67-75 Piccadilly, Manchester – Application for Non-Material Amendments to Planning Permission ref. 127538/FO/2020

On behalf of our client, Southern Green Properties Ltd (the 'Applicant'), we hereby submit an application under Section 96(a) of the Town and Country Planning Act 1990 (as amended) in order to make Non-Material Amendments ("NMA") to Planning Permission 127538/FO/2020.

Appendix 1

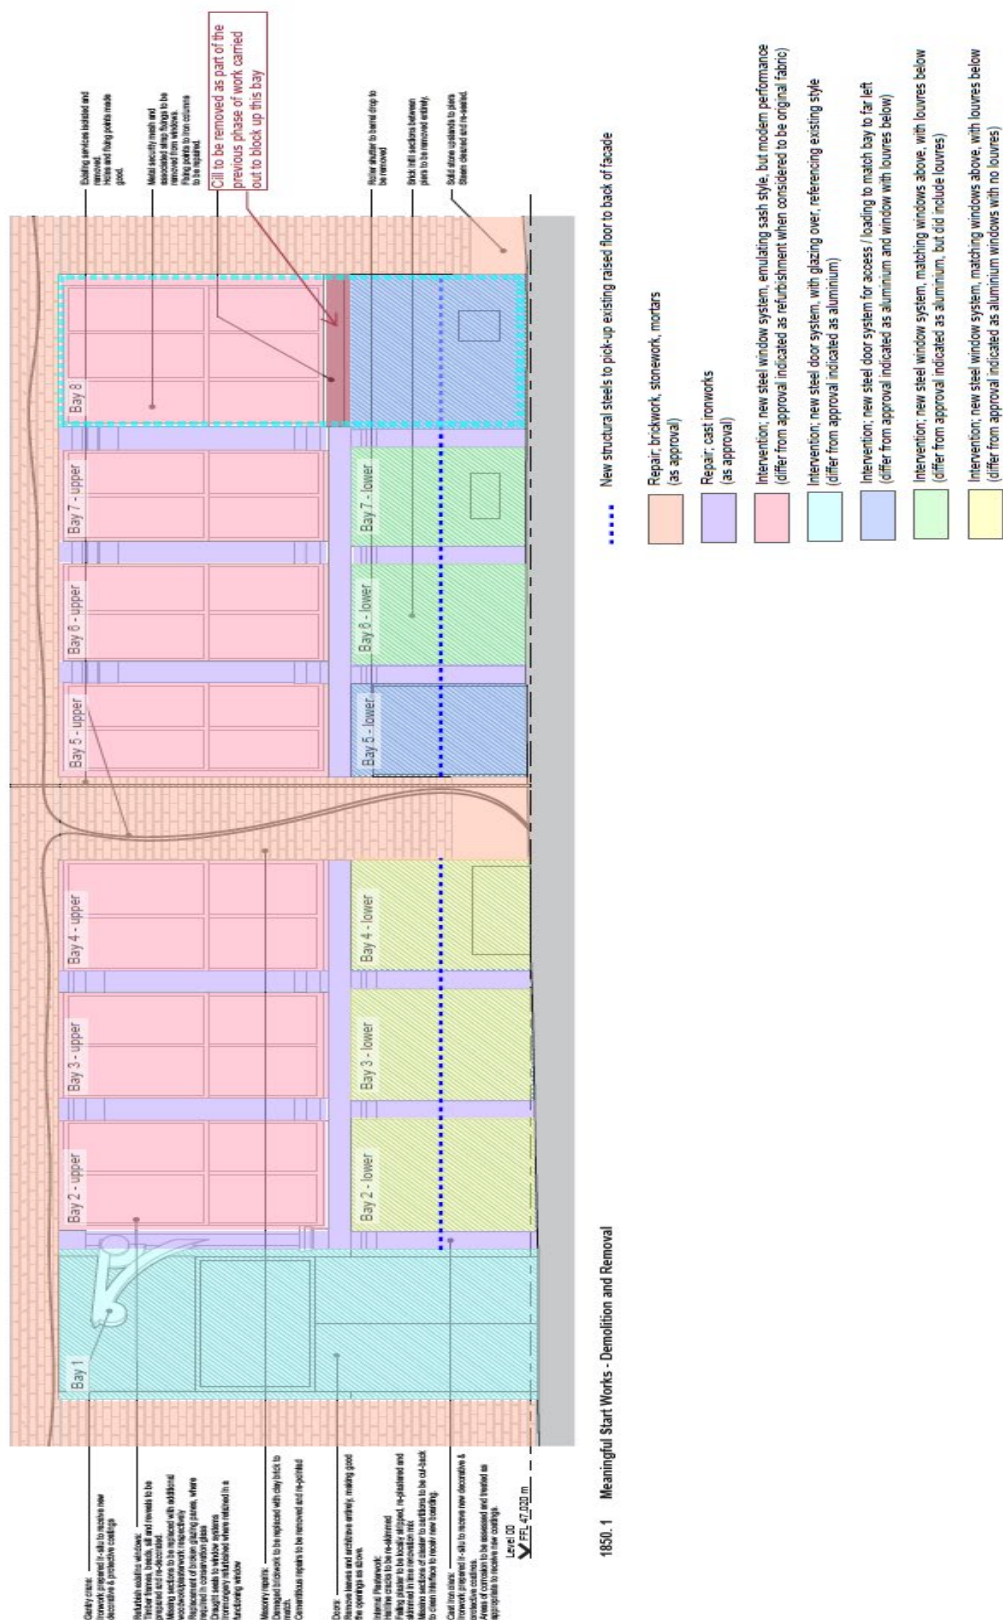
Following progression of the design to RIBA Stage 4, a number of design adjustments are being proposed to the Back Piccadilly elevation to facilitate the future operation of the building. These have been summarised in the list below and as shown in Appendix 1:

- Following further investigation at detailed design stage it is clear that the fabric of the original timber windows at upper ground level are fragmented and in poor condition. Consequently, there is unlikely to be much residual fabric. As such it is proposed that a steel window frame is installed at this location which will better match the aesthetic of the original timber sash windows and negate the need for secondary glazing; and

- The beer drop which was previously proposed as ventilation louvres is proposed to move to bay 8 on the below diagram. The new door in bay 8 and the need to increase the ventilation louvre provision to accommodate the loss at this bay has resulted in an opportunity to create a symmetrical façade on this elevation to better reflect the historic condition. As such, it is proposed to introduce part window part louvre units to replace the existing brick infills at lower ground floor.

As a result of the above changes, Condition 2 is being amended in order to reflect the revised elevational drawing (Ref. 1936-FCBS-ZZ-ZZ-PL-A-0805 Rev A) being submitted. This change is highlighted in Appendix 2.
